SEWAGE DISPOSAL SYSTEM

HOWARD COUNTY

SUBDIVISION Twelve Hills ROAD 13009 Twelve Hills Ct. LOT 17, Sec. 2

Re: Building Permit - 37699  
Proposed Deck  
13009 Twelve Trees Court

SITE PLAN

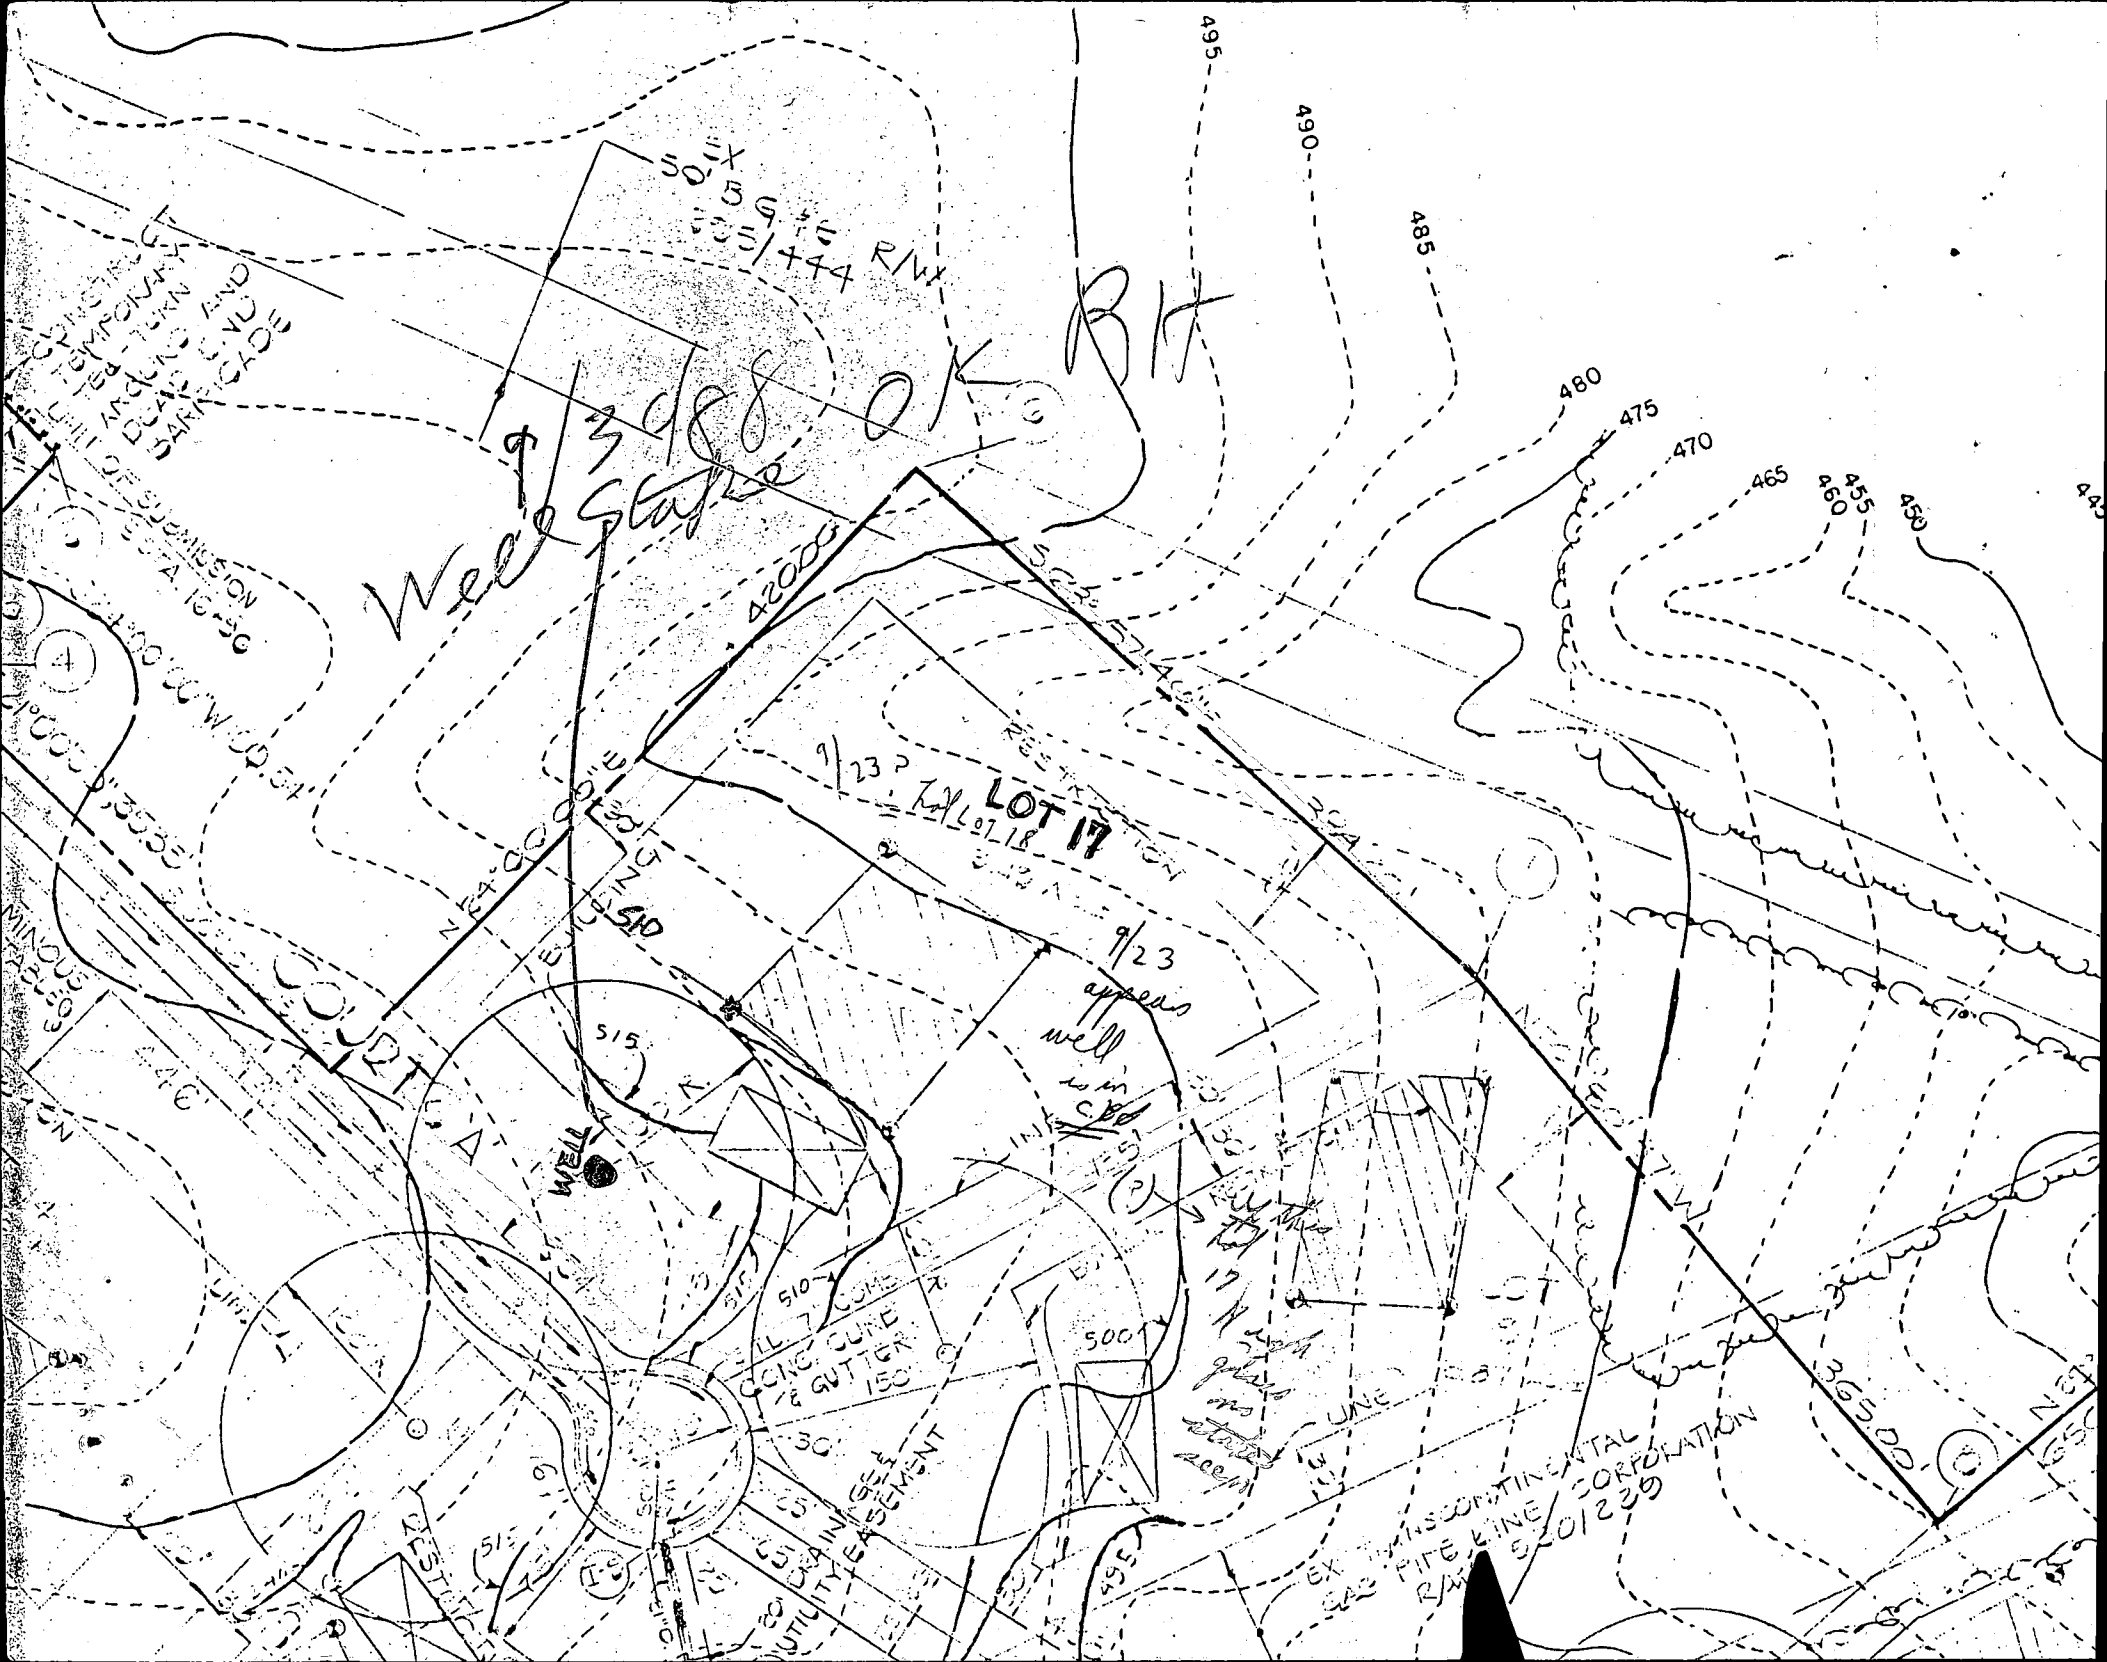
SEPTIC AS PG DRAWING  
OK TO PROCEED

Location Survey of #13009 TWELVE TREES CT.		Job no. 1000
	Vitti, Robel and Associates, Inc.		Scale 1" = 40'
	ENGINEERING & SURVEYING		Date 5-9-91
	1717 York Road Suite 2B Lutherville, MD 21093		Drawn 7/1/91
	252-1652		checked 3/1/92

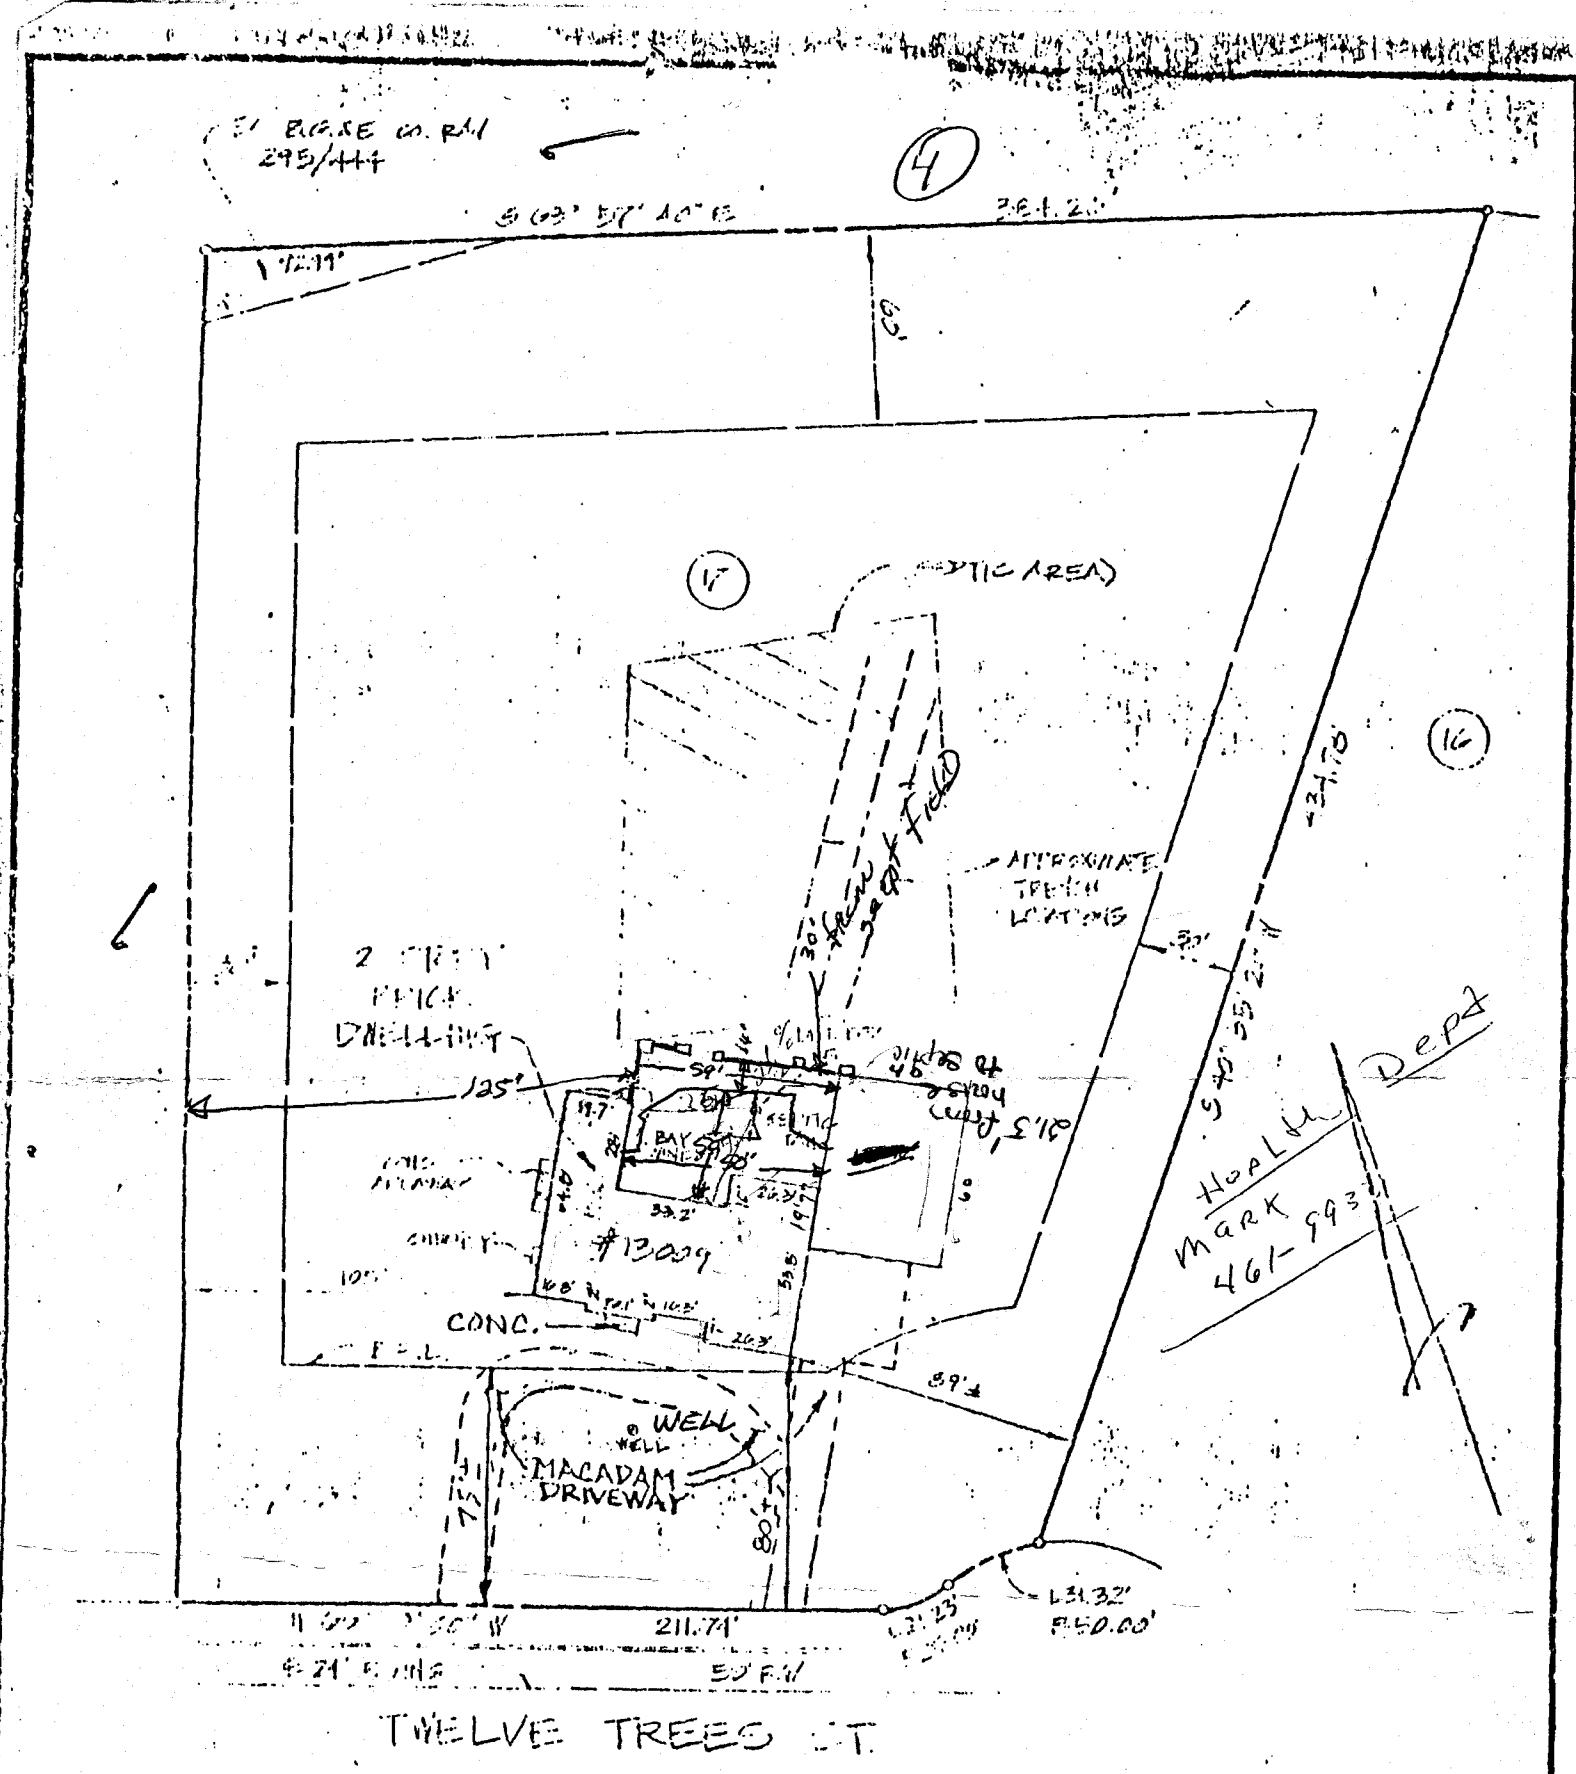
5-8-91 BP # 37699 Inspection made. Contractor says no bathrooms will be added. Addition forms a courtyard like enclosure. Deck will be built around septic system. Plans for the deck to be suspended above and around septic tank. No cleanouts were found for septic system.  
D. Buggs

The concern is adequate clearance from the deck to the septic system. The submitted plan provides insufficient detail to determine the dimensions is involved.

Per the results of a field inspection conducted May 8, 1991, it is my understanding that; "The proposed addition forms a courtyard like enclosure. Deck will be built around septic system. Plans for the deck to be suspended above and around septic tank." Maryland individual water and sewage disposal regulation establishes the minimum approvable separation from structures to septic systems to be 10' to septic tanks and 20' to disposal fields. Minor infringements on these distance requirements are commonly granted for "removable" structures such as decks and storage sheds, not involving poured slab or foundation, as long as full access to the septic system is not compromised and no foreseeable health risk is involved.

However, is not clear that your proposal meets this test. An accurately scaled drawing which provides dimensions to the septic system and construction detail at the nearest points to the system is required to complete the review. From the available information, there is significant concern as to whether or not this permit application can be recommended for approval.

Also, during the site inspection, no septic tank cleanouts were visible. In Howard County, new septic system installations are required to maintain septic tank cleanouts flush with grade or above. Please notify this office for inspection when this deficiency has been corrected.

5/13/91 CONVERSATION WITH BUILDER DISCUSSING "ACCESS".  
I EXPLAINED THAT ALLOWING DECK WITHIN A FEW FEET OF TANK  
AND WITHIN 10' OF TRENCHES WAS ALREADY A CONCESSION  
TO LITERAL INTERPRETATION OF REGULATION.

I RESPONDED THAT DECK BUILT AROUND TANK WOULD STILL  
ALLOW ADEQUATE ACCESS VIA CRANE.  
WE DISCUSSED THE MECHANICS OF REPLACING/SERVICING  
THE TANK AND AGREED TO DISCUSS THE MATTER  
WITH OUR "SUPERVISORS".  
HE WILL BE IN TOUCH TOMMORROW NOON FOR FINAL DETERMINATION.  
*C Williams*

5/15 OWNER + BUILDER CAME IN TO DISCUSS.  
WILL BE APPLYING TO RELOCATE TANK.  
OK TO PROCEED.  
*C Williams*
